MISSISSIPPI POWER & LIGHT COMPANY

SUBJECT: Grand Gulf Nuclear Station
Unit 1
Docket No. 50-416
License No. NPF-13
File 0260/L-350.0/0092
Comments and Status on Grand Gulf
Operating License and Safety
Evaluation Report
AECM-82/358

ATTACHMENT 1

SUMMARY OF VARIOUS LICENSE CONDITIONS REFLECTING
CURRENT STATUS AND/OR MP&L POSITIONS.

MP&L OPERATIONAL QUALITY ASSURANCE PROGRAM
 ORGANIZATION FIGURE 17.2-1

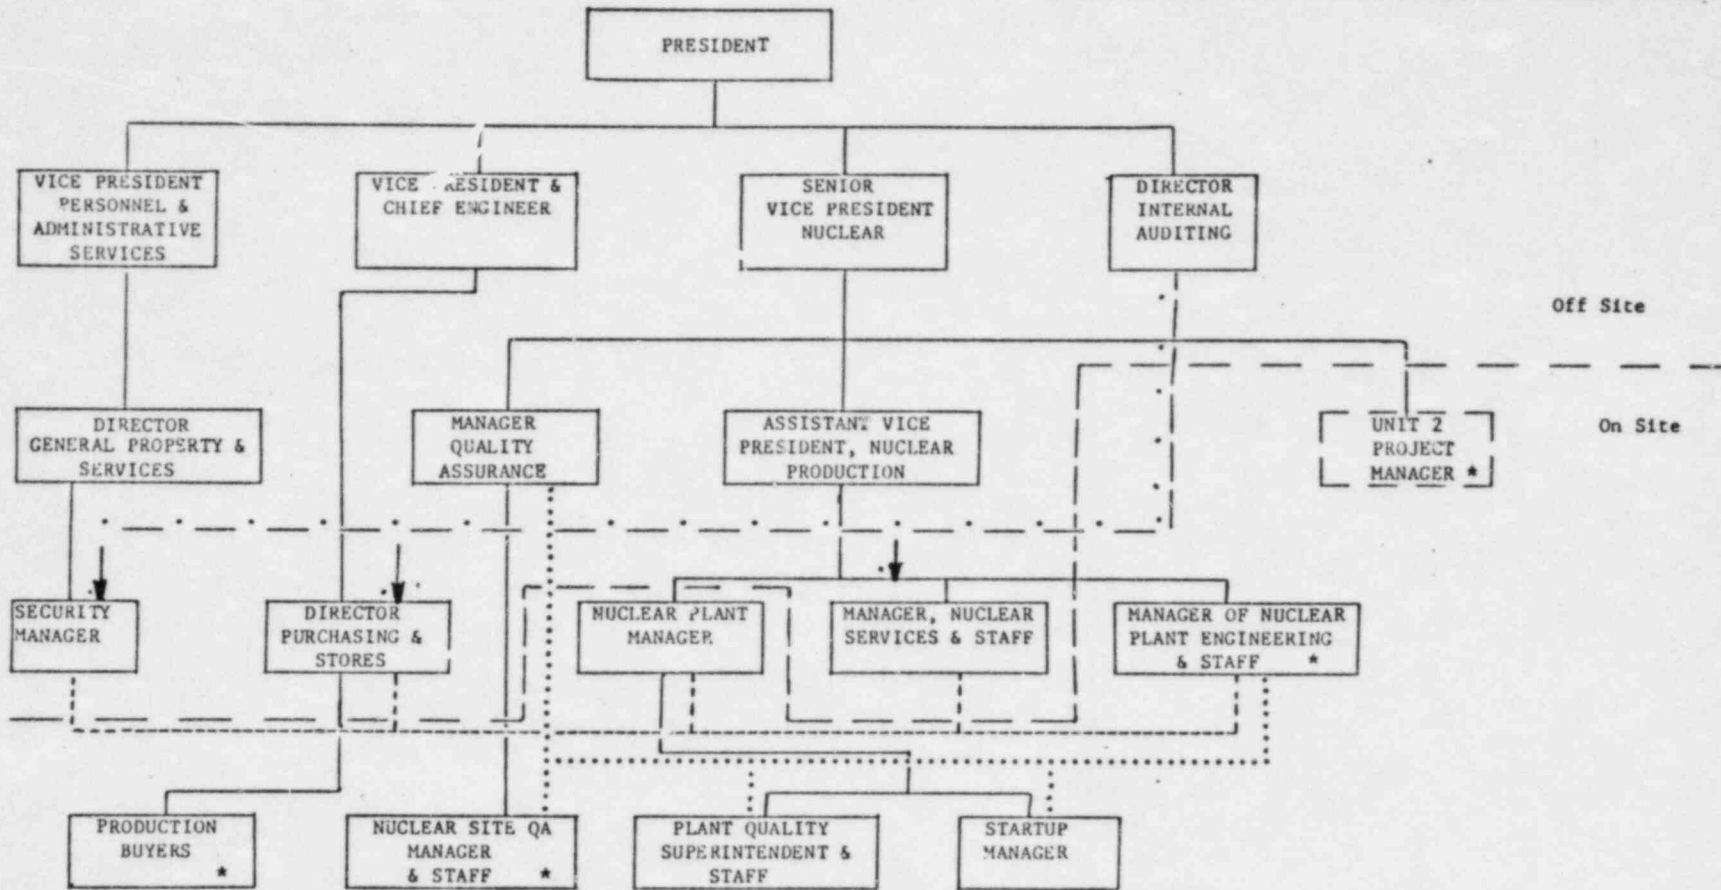
The following letter is provided to clarify Quality Assurance organizational and programmatic policy changes within MP&L. This letter was previously transmitted to the NRC on May 21, 1982; however, the items were not incorporated into the GGNS SER supplements.

Attached for your consideration is a proposed revision to SER Chapter 17. This revision is provided to clarify the organizational and programmatic policies outlined in MP&L's Operational Quality Assurance Manual, MPL-TOP-1A, which has been accepted by the NRC.

The structure of the organization responsible for the operation of Grand Gulf Nuclear Station, Units 1 and 2, and for the establishment and execution of the operational phase QA program is shown in Figure 17.1. The Senior Vice President - Nuclear, who reports to the President, has been delegated ultimate responsibility for the safe and reliable operation of the Grand Gulf Nuclear Station. He provides guidance and Corporate QA policies, goals, and objectives to the Manager of Quality Assurance.
